# **Notice of Intent**

**Sundry ID: 2837454**

**Procedure Description:** Devon Energy Production Co., L.P. (Devon) respectfully requests a change to the drilling plan for the Morgan 25-13 Fed Com 305H, 616H, 625H, 715H and 735H to include break test variance with stump testing . Attachment included.

# PECOS DISTRICT DRILLING CONDITIONS OF APPROVAL

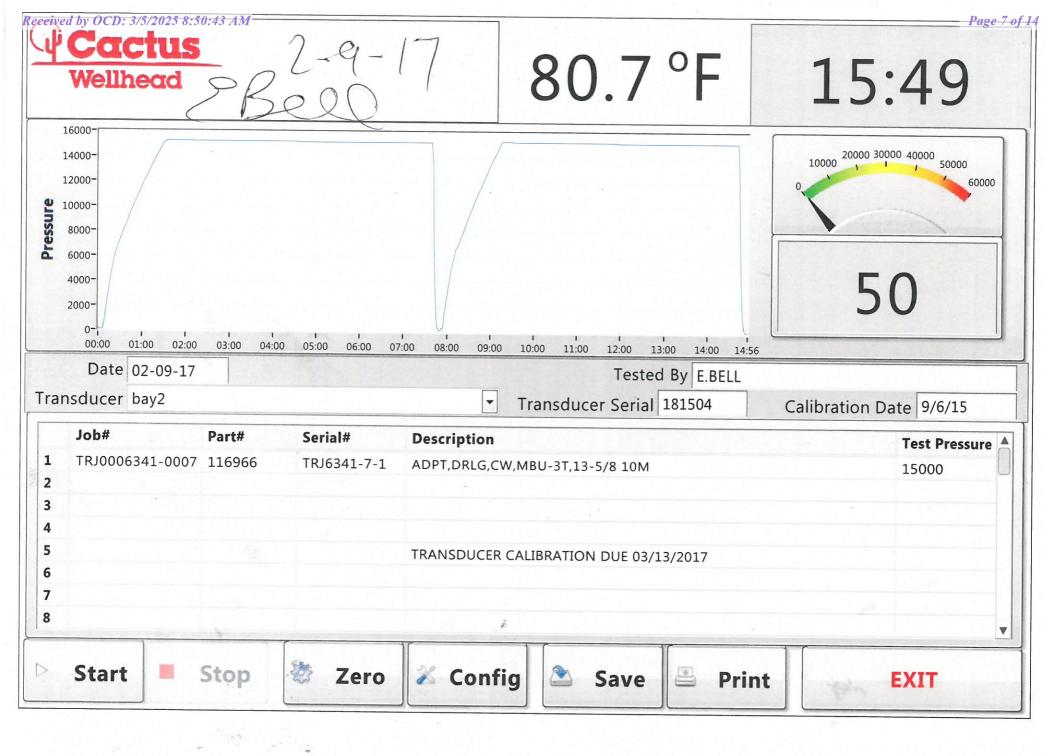
Devon requests offline BOPE testing for the following components: Upper Rams, Blind Rams, Kill Valves, Choke Valves, and Annular Remaining well control equipment components will either be tested offline or online, per BLM approval

Remaining BOPE will be tested online within 72-hours form completing the offline BOPE component testing

Notify the BLM if the online BOPE testing exceeds 72-hours

All Full Tests not completed "Offline" or "Offline, BOPE" are required to be complete Online

Devon requests Break testing as stated above for 5K tests, not including production hole

$Annular\ Preventer\ will\ be\ tested\ to\ minimum\ of\ 70\%\ RWP\ and\ higher\ than\ MASP\ during\ initial\ BOP\ test$

Pressure testing is required for pressure-containing connections if the integrity of a pressure seal is broken during a break test Full Tests required when entering production hole

All Previous COAs Still Apply. Variance request procedure is approved as written, please see below general conditions for variance.

Operator has been (Approved) to test the BOPE offline.

The BOPE offline testing shall be stationary during pressure testing.

Online BOPE testing should commence within 72 hours of offline BOPE testing completion. Notify the BLM if interval exceeds 72 hours.
